SUZUKI

Service Bulletin

Bulletin No: GENERAL-15

Subject: CLUTCH RATTLE ON TWIN CYLINDER
MODELS

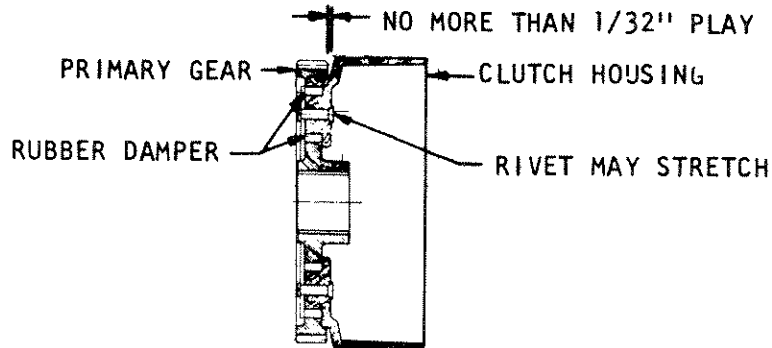
- A. The clutch housing/primary gear is a riveted assembly. There are rubber dampers which cushion the drive shock between these two parts. If the rivets stretch or the dampers soften, the clutch housing will wobble and make the same noise. Try to separate the two parts with your hands.

There should be less than 1/32 inch play between the two parts. Don't try to tighten the rivets. Instead, replace the assembly.

WRONG

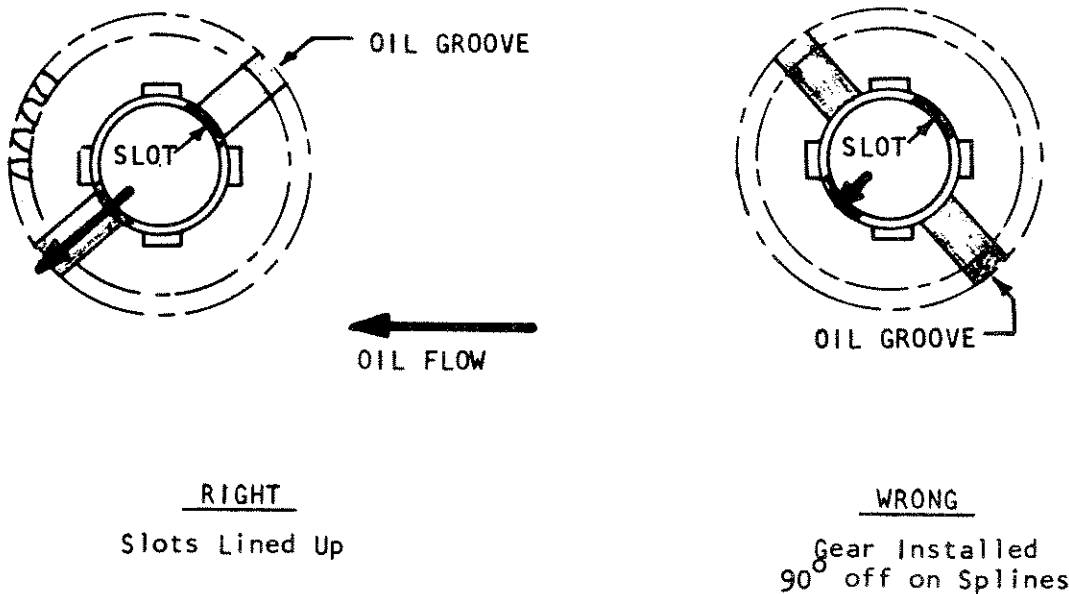
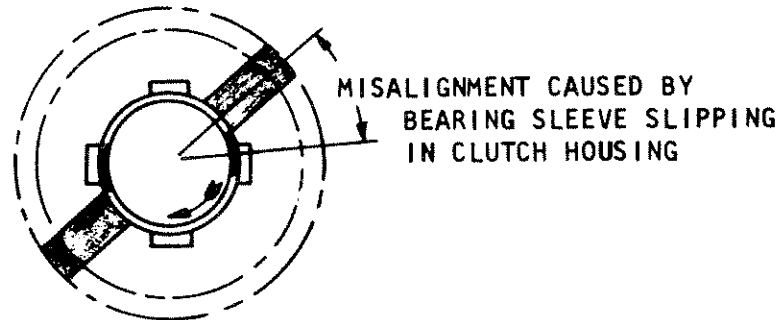
- B. Check the clutch hub nut and the primary pinion nut for tightness. Use a torque wrench when tightening these critical nuts.
- C. The X6, TC250, T200, TC200, T250, T305, TC305, T350, clutch housing is fitted with the kickstart drive gear on its backside. Be sure that the oil grooves in the gear are matched with the slots in the clutch bearing sleeve. Otherwise, the thrust face of the housing will prematurely wear due to lack of oil.

Bearing has seized on shaft, causing sleeve to slip in housing.

- D. If the transmission oil level is too low, or if extreme heat is present in the clutch assembly, the clutch housing bearing will seize on the transmission driveshaft. The engine will stop suddenly, and the inertia of the rolling motorcycle will cause the clutch bearing sleeve, which is pressed into the housing, to spin in the housing. After it frees up, the clutch will work well. However, the thrust surface of the clutch housing will starve for oil and wear too quickly, again causing this "rattling" noise.
- E. Another possible cause is transmission oil level too low. Or the transmission oil viscosity is incorrect. The correct type is a 20W-40 multigrade detergent.
